# Proposed Revision to VE Acceptance Criteria of ASME Code Case N-729-x (-3140)

**Chris Wax, Craig Harrington EPRI**

NRC Virtual Public Meeting May 11, 2022 1:30 to 3:30 pm ET

### **VE at Masked Penetrations**

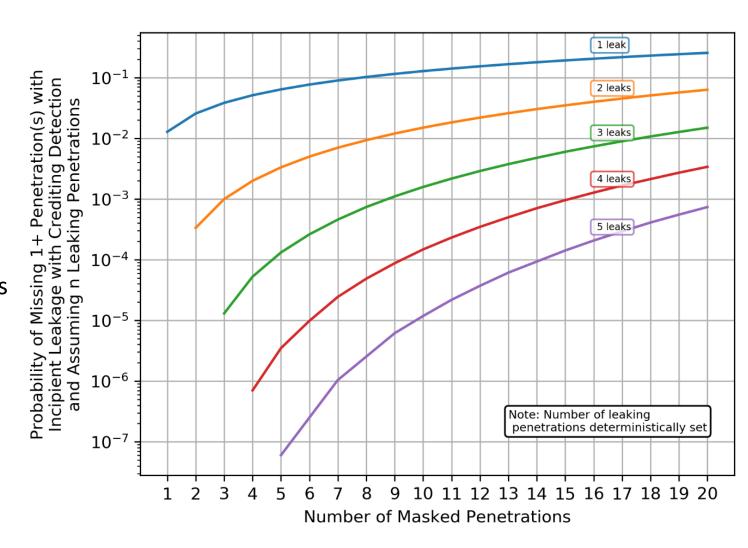
- A new paragraph -3141(e) is proposed: "The relevant conditions at masked penetrations (defined in -9000) shall be evaluated in accordance with -3142.1(b)(1) for evidence of head penetration leakage accompanying the masking leakage from another source as practical given the extent of masking local to the intersection of each penetration and the head upper surface."

- This paragraph makes clear that the evaluation for the source of the relevant condition must consider the possibility of head penetration leakage occurring at a penetration that is masked with deposits from a source other than head penetration leakage

- This evaluation shall consider the information that is relevant and that can be reasonably obtained for the relevant condition in the area of a masked penetration

- However, the chance of detecting head penetration leakage (if it is in fact present) is reduced compared to the situation if there was no masking, and the extent to which the capability is affected depends on the extent of masking deposits that are present
